Staff Report

Re: PLNPCM2021-00822 and PLNPCM2021-00835 Pacific Yard

Planned Development and Design Review

PROPERTY ADDRESS: 443 W 700 South, 720 S 400 West, 704 S 400 West

FIRST FLOOR PLAN

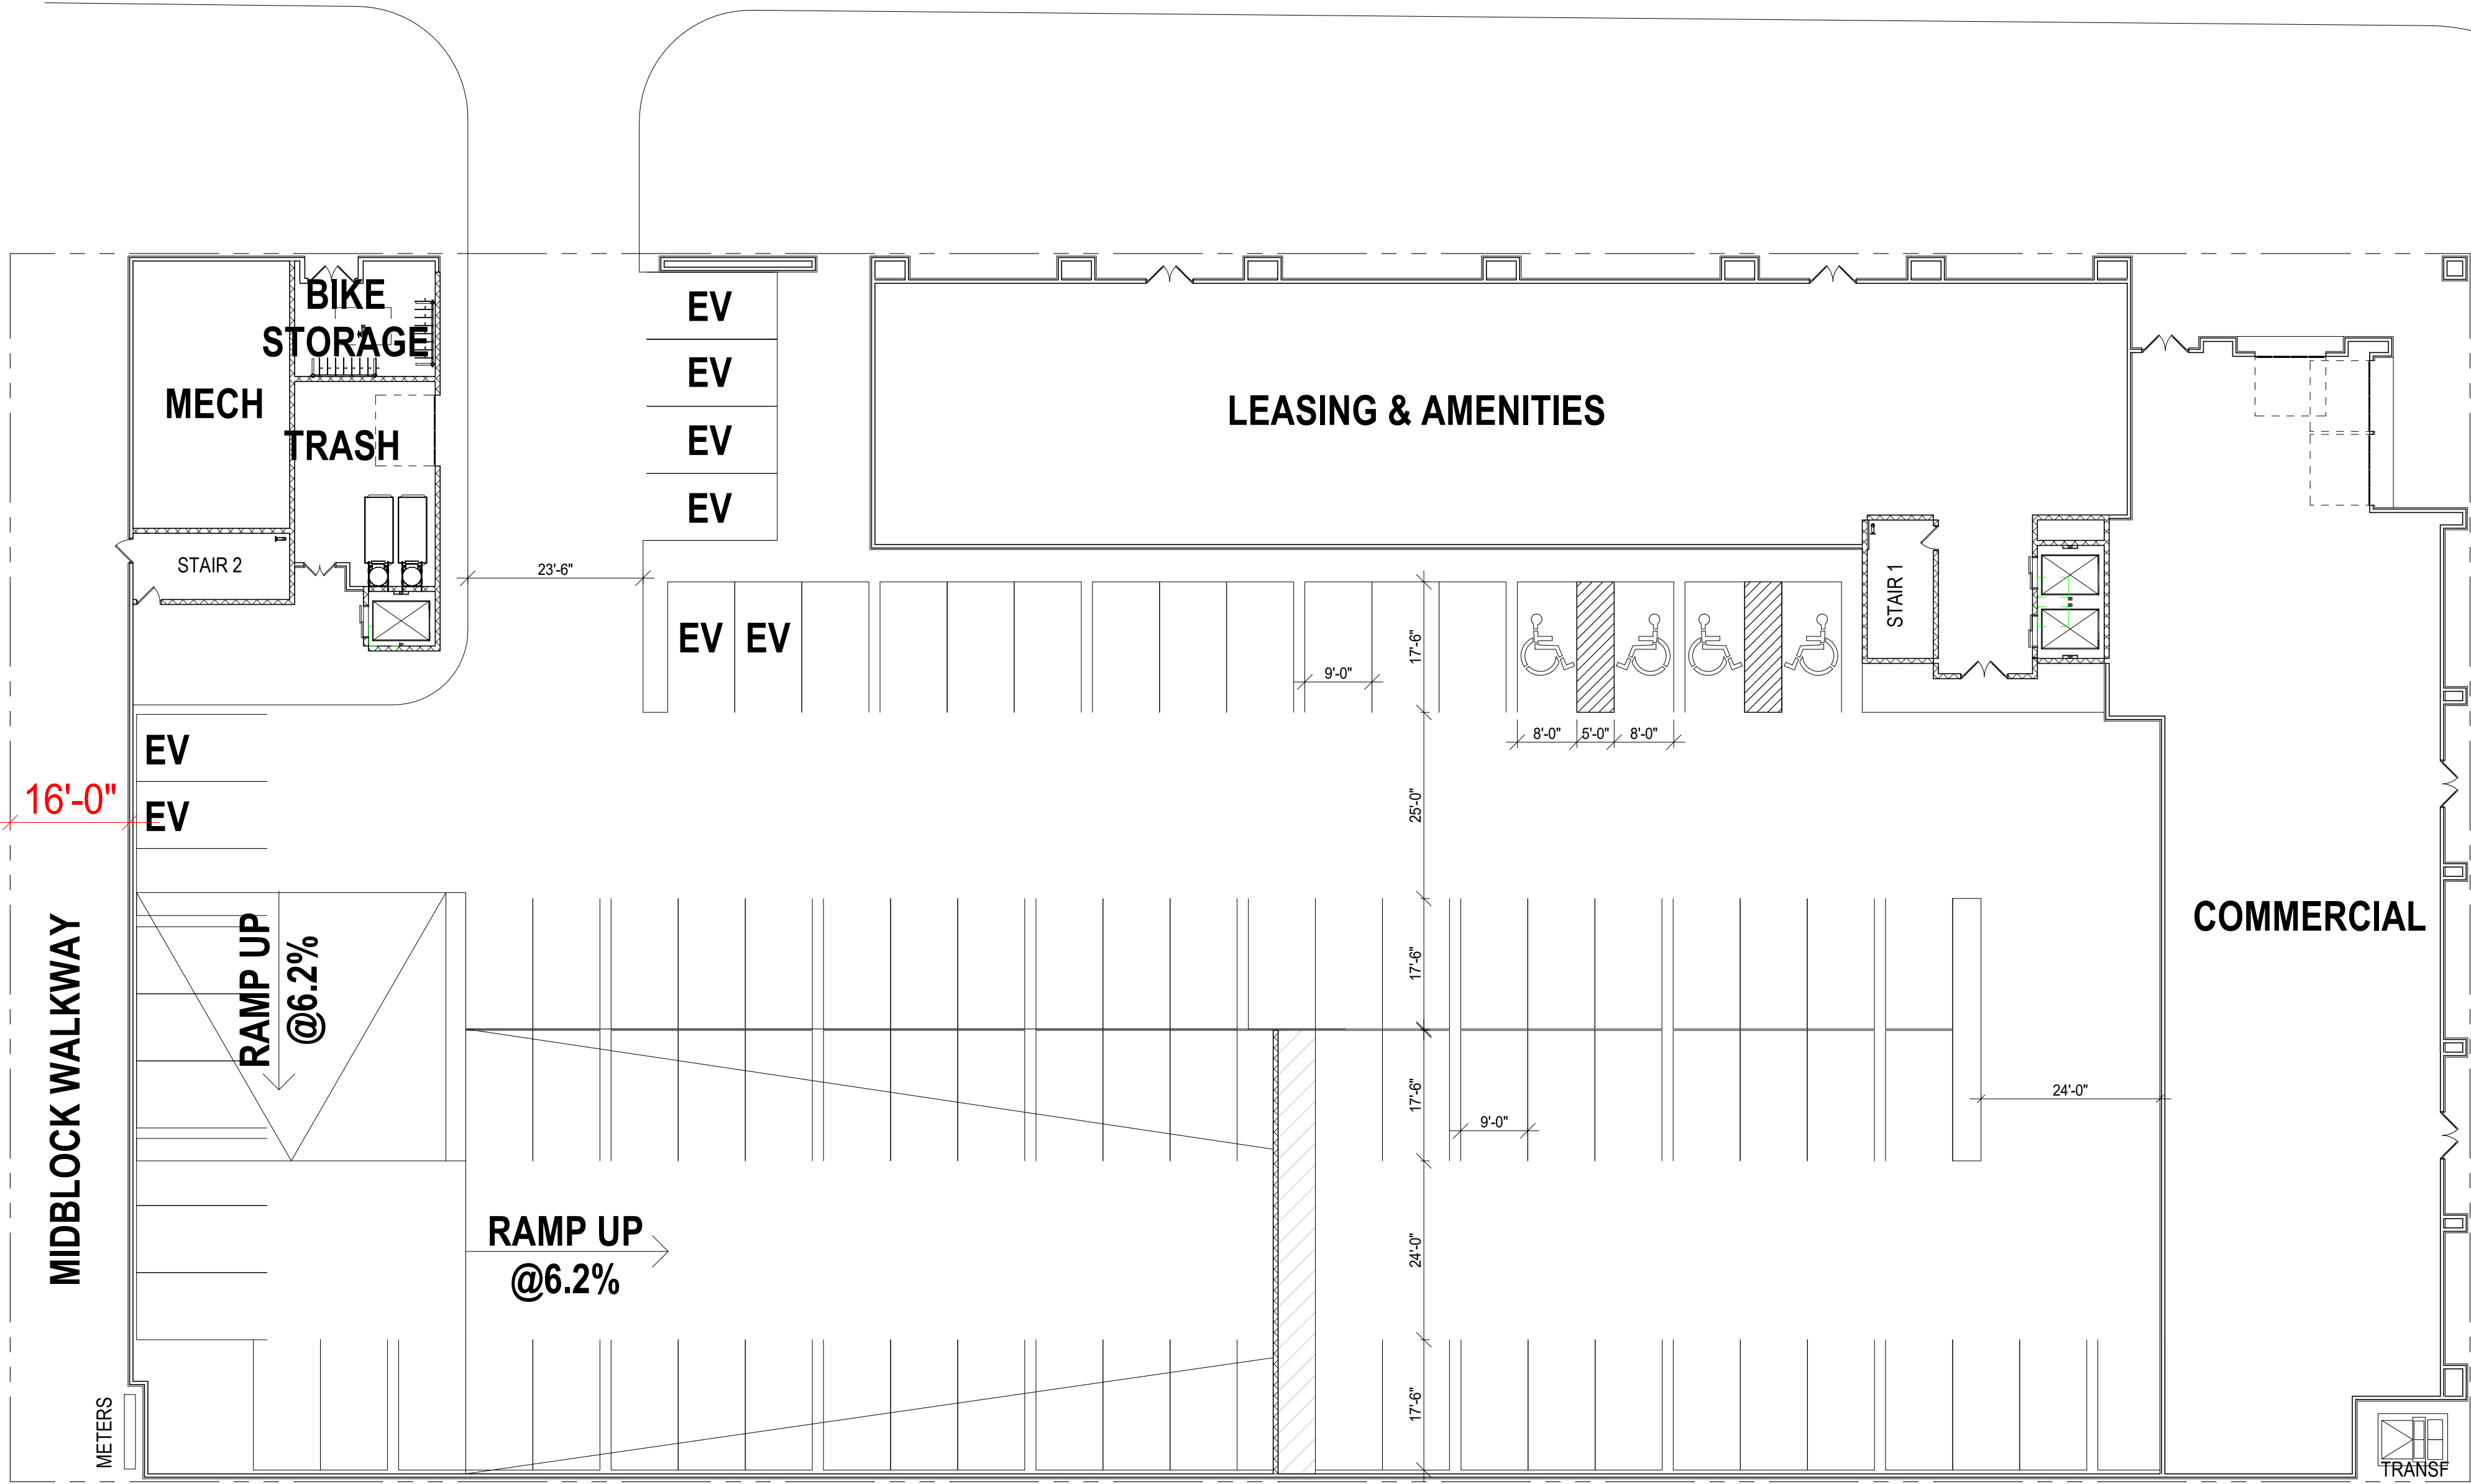
The parking calculations on sheet 9 of 18, "A-01 First Floor Plan", of "2021-1029_704 S 400 W-Design Review Drawings (24x36)" show the minimum parking required as 215 parking spaces and the parking provided as 208 parking spaces. The applicant should check/verify the parking calculations.
